CHATHAM COUNTY PURCHASING & CONTRACTING DEPARTMENT

ADDENDUM NO. 2 TO 18-0075-4

FOR: CANEBRAKE ROAD IMPROVEMENTS

Canebrake Road – Plan Revisions – 7/31/18

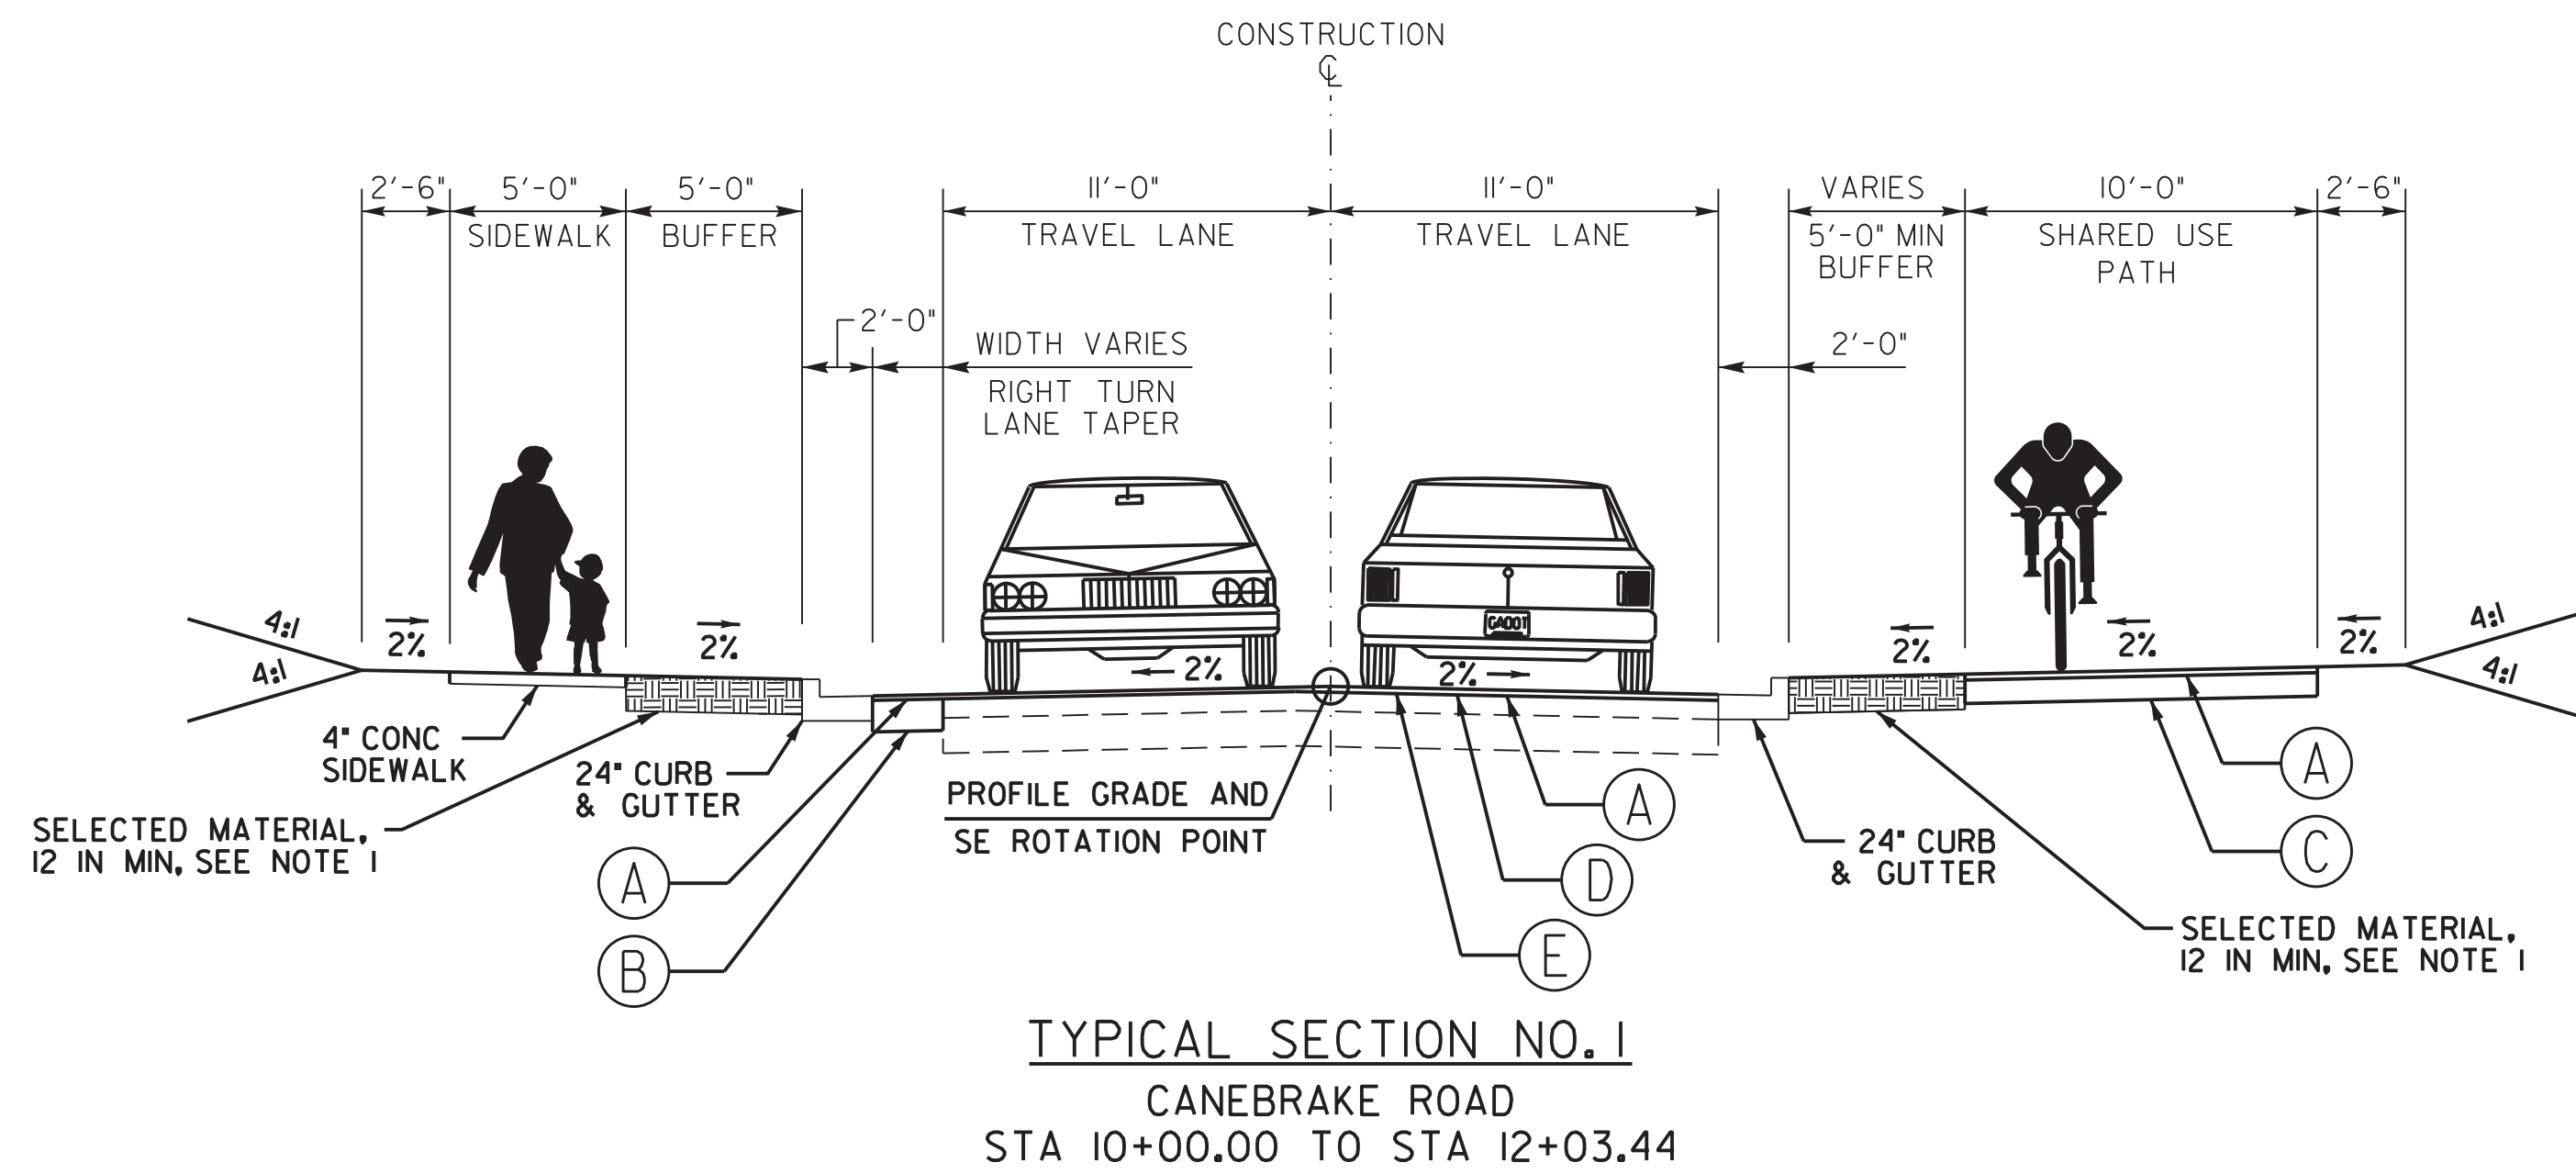
Sht 04-001: Added Hargray Communications to list of Utility Owners

NAME OF UTILITY OWNER	UTILITY	PHONE
AGL RESOURCES	GAS	(912) 239-6508
AT&T	PHONE	(912) 964-7346
GEORGIA POWER COMPANY	ELECTRIC	(912) 944-0641
COMCAST	CABLE	(912) 356-3161
CITY OF SAVANNAH	WATER & SEWER	(912) 651-6573
HARGRAY COMMUNICATIONS	TELECOMMUNICATIONS	(843) 815-1683

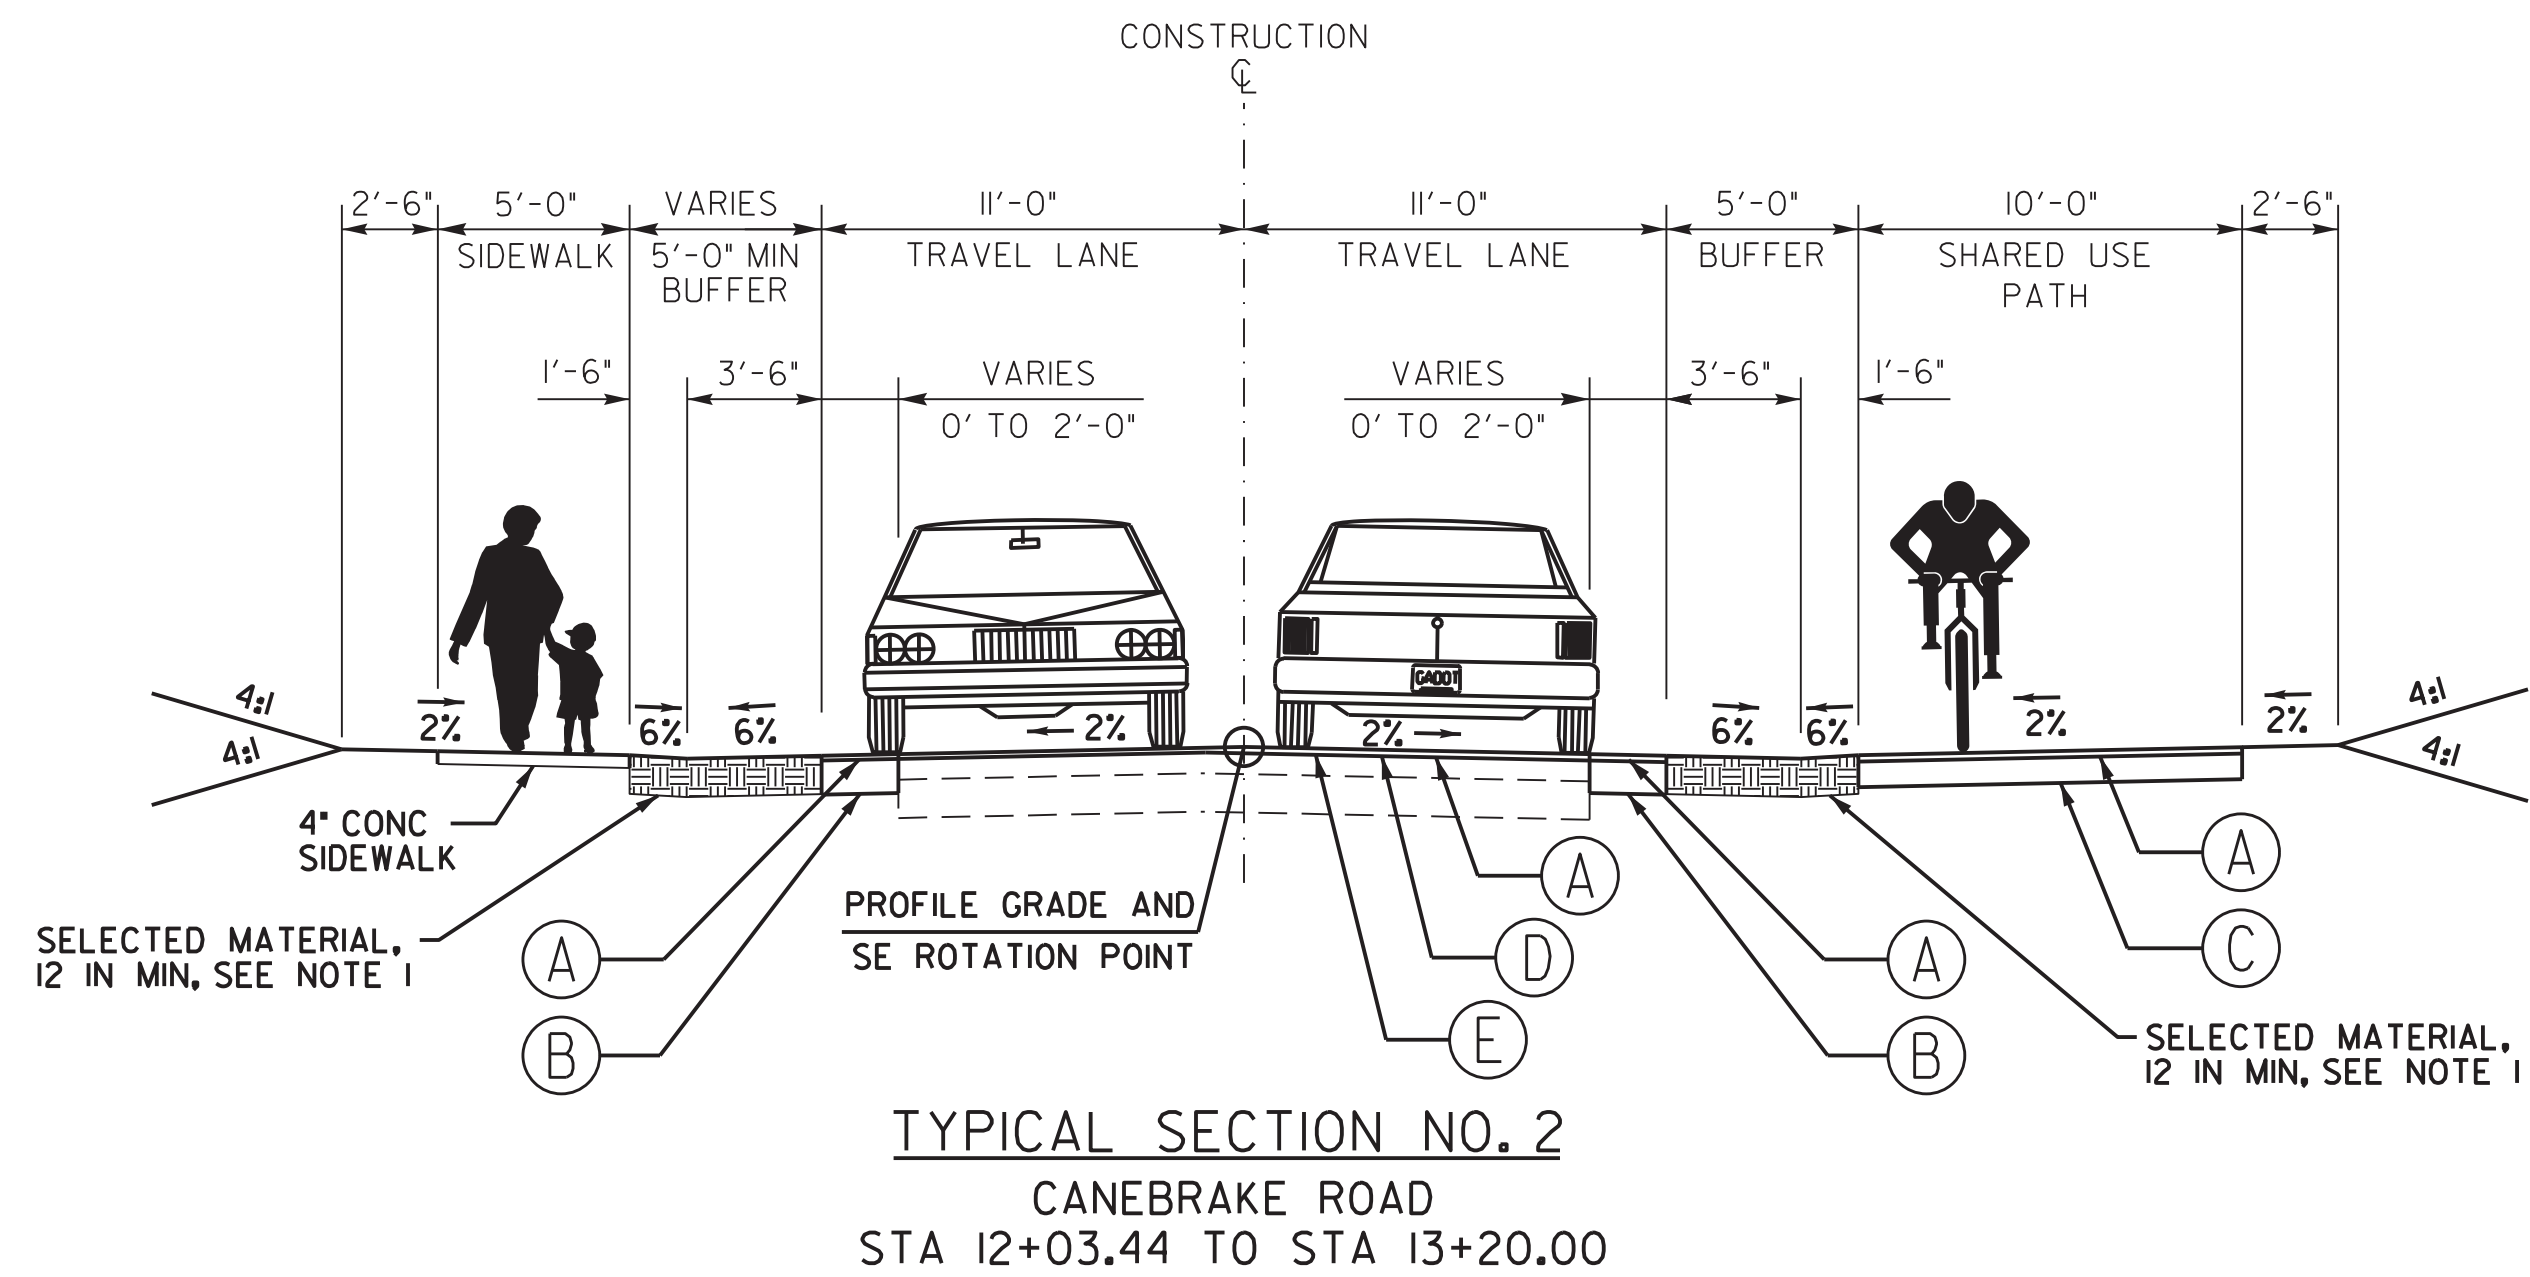
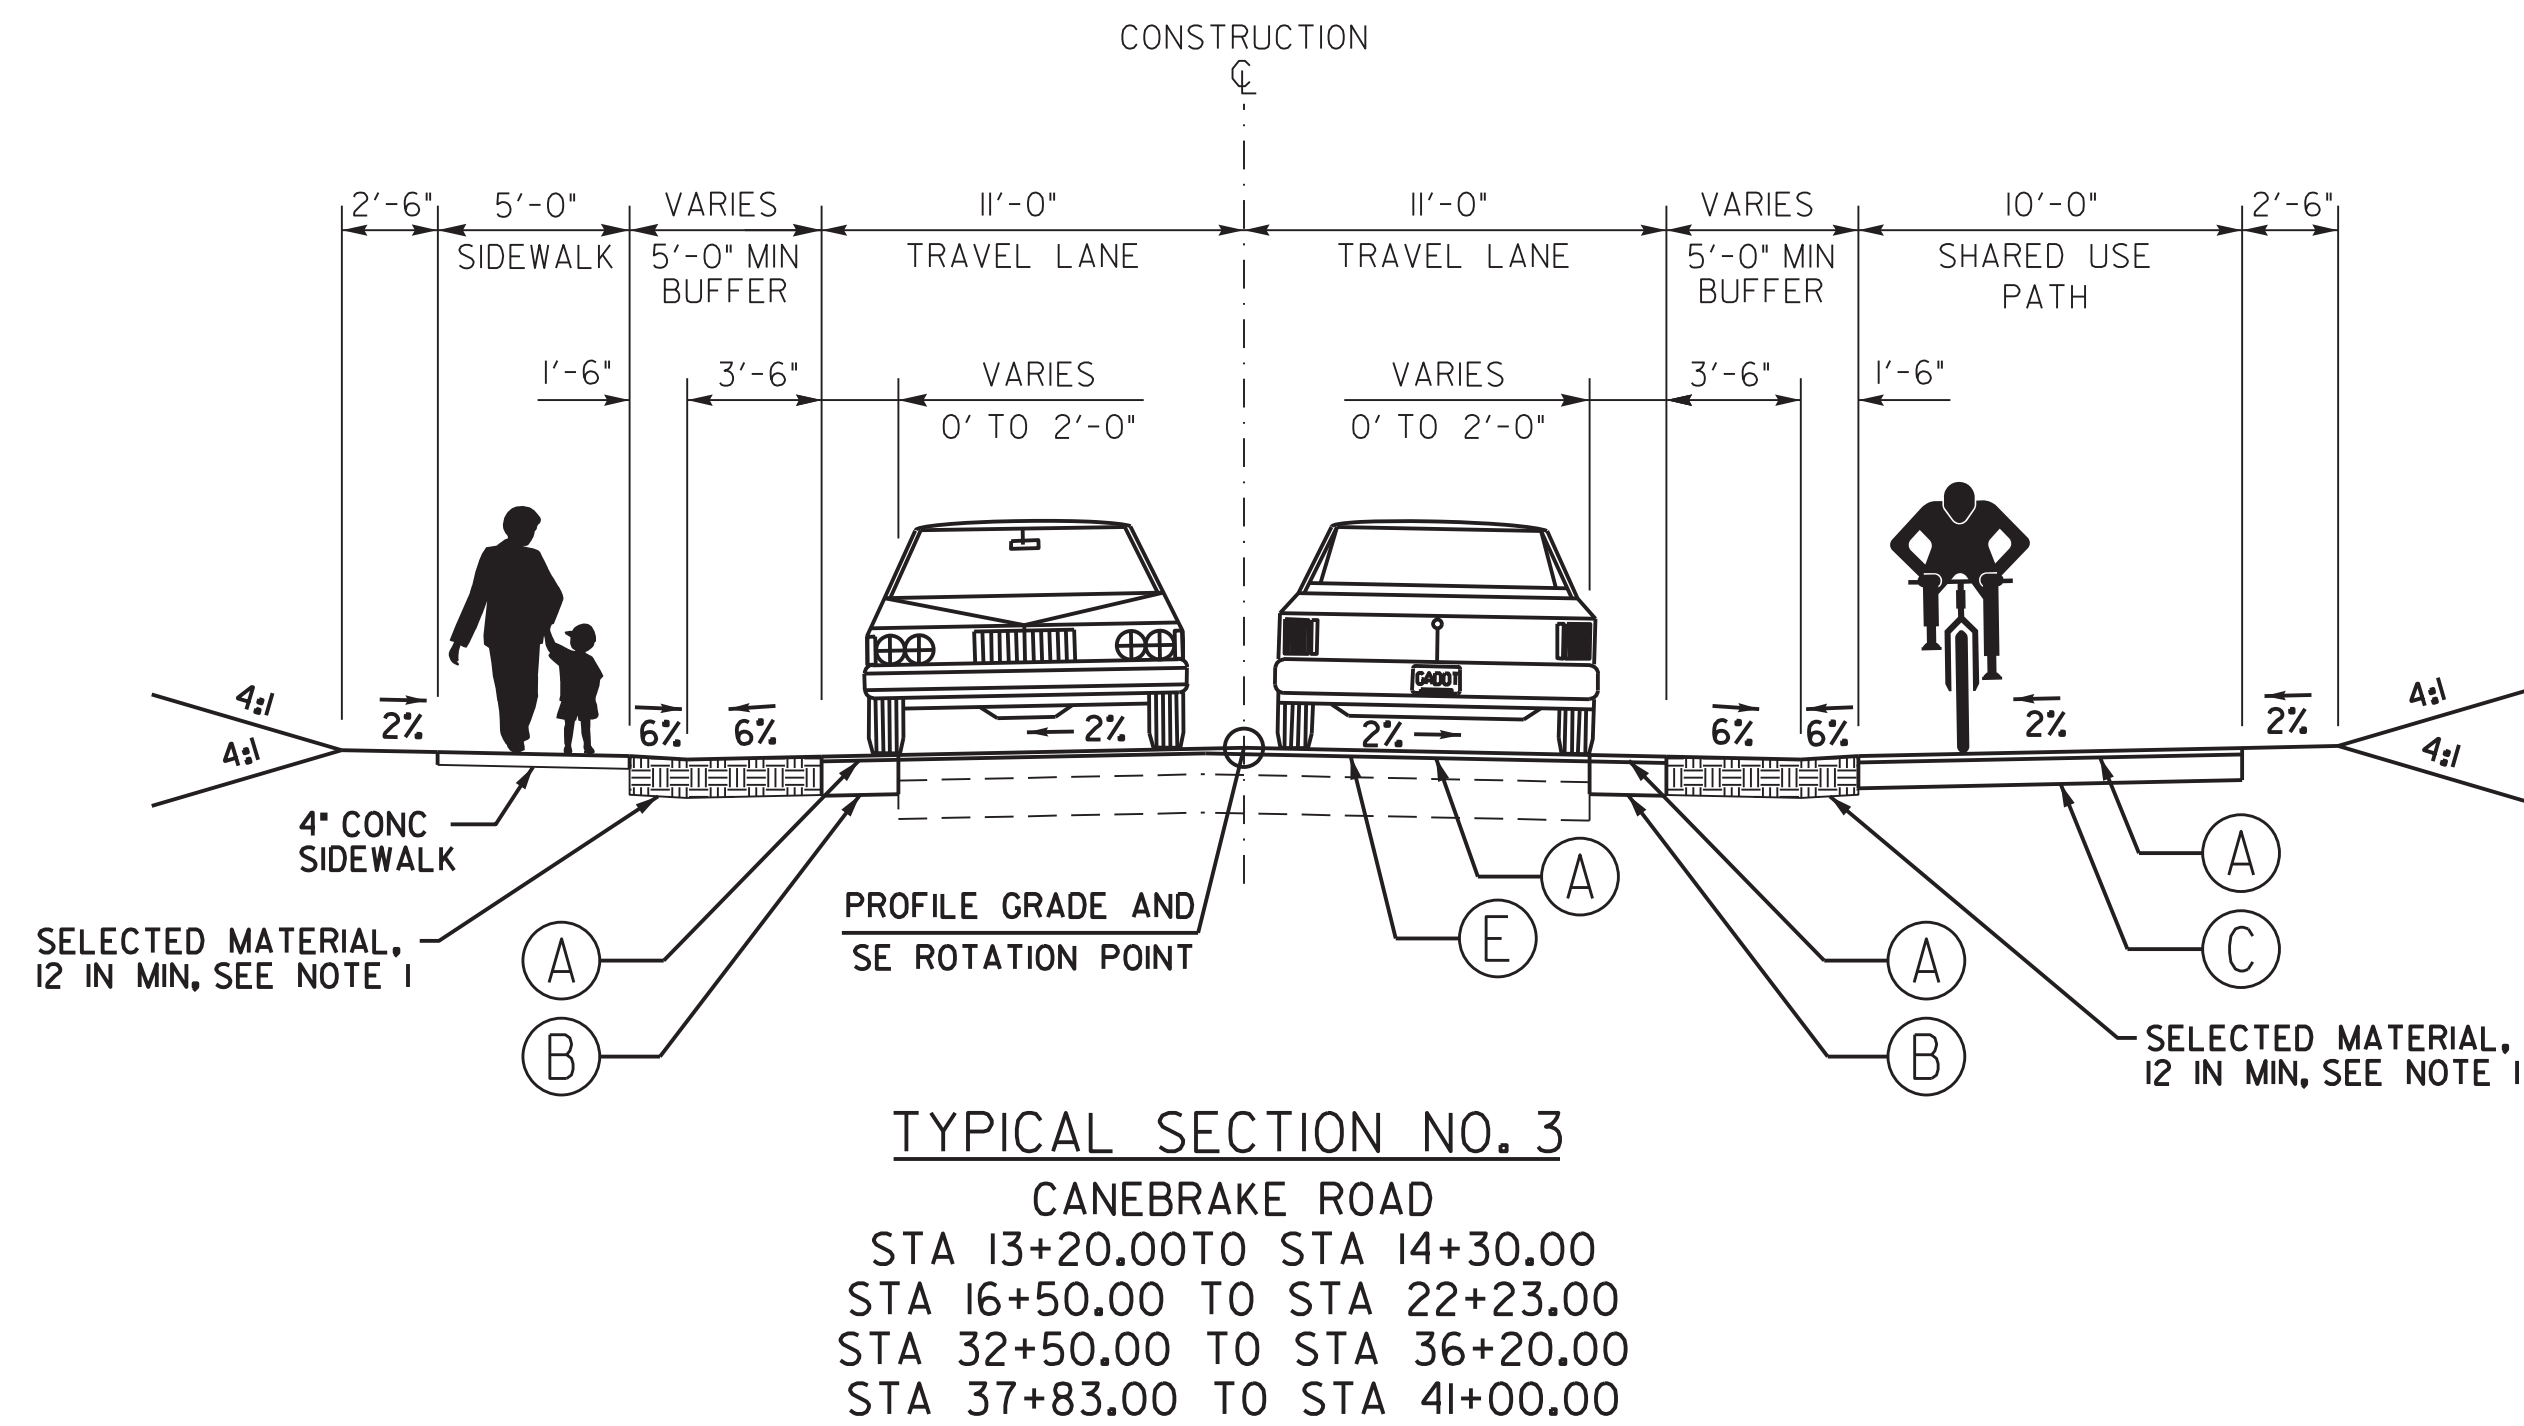
Shts 05-001 thru 05-006:

Added the following note:

NOTE 1. CONTACTOR TO ENSURE PLACEMENT OF A MINIMUM DEPTH OF 12-INCHES OF SELECTED MATERIAL WITHIN THE BUFFERS BETWEEN THE ROADWAY AND SIDEWALK OR TRAIL IN ACCORDANCE WITH GDOT STANDARD SPECIFICATION 216-UNPAVED SHOULDERS. PAYMENT FOR THIS WORK SHALL BE PER SQUARE YARD FOR THE UNIT PRICE BID FOR ITEM 216-9000-SELECTED MATERIAL FOR SHOULDER CONSTRUCTION, 12 IN MIN, INCLUDING MATERIAL. SELECTED MATERIAL SHALL BE CLASS IA1 MATERIAL IN ACCORDANCE WITH GDOT STANDARD SPECIFICATION 810, WITH LESS THAN 5% CLAY.

Sht 05-001: Added Leveling to Typical Section Nos. 1 and 2

NOTE 1. CONTRACTOR TO ENSURE PLACEMENT OF A MINIMUM DEPTH OF 12 INCHES OF SELECTED MATERIAL WITHIN THE BUFFERS BETWEEN THE ROADWAY AND SIDEWALK OR TRAIL IN ACCORDANCE WITH GDOT STANDARD SPECIFICATION 216-UNPAVED SHOULDERS. PAYMENT FOR THIS WORK SHALL BE PER SQUARE YARD FOR THE UNIT PRICE BID FOR ITEM 216-9000 SELECTED MATERIAL FOR SHOULDER CONSTRUCTION, 12 IN MIN, INCLUDING MATERIAL. SELECTED MATERIAL SHALL BE CLASS 1A1 MATERIAL IN ACCORDANCE WITH GDOT STANDARD SPECIFICATION 810, WITH LESS THAN 5% CLAY.

- A 220 LB/SY ASPHALTIC CONCRETE 12.5MM SUPERPAVE
- B 8" CLASS "B" CONCRETE
- C 8" GRADED AGGREGATE BASE
- D VARIABLE DEPTH MILLING
- E LEVELING AS REQUIRED
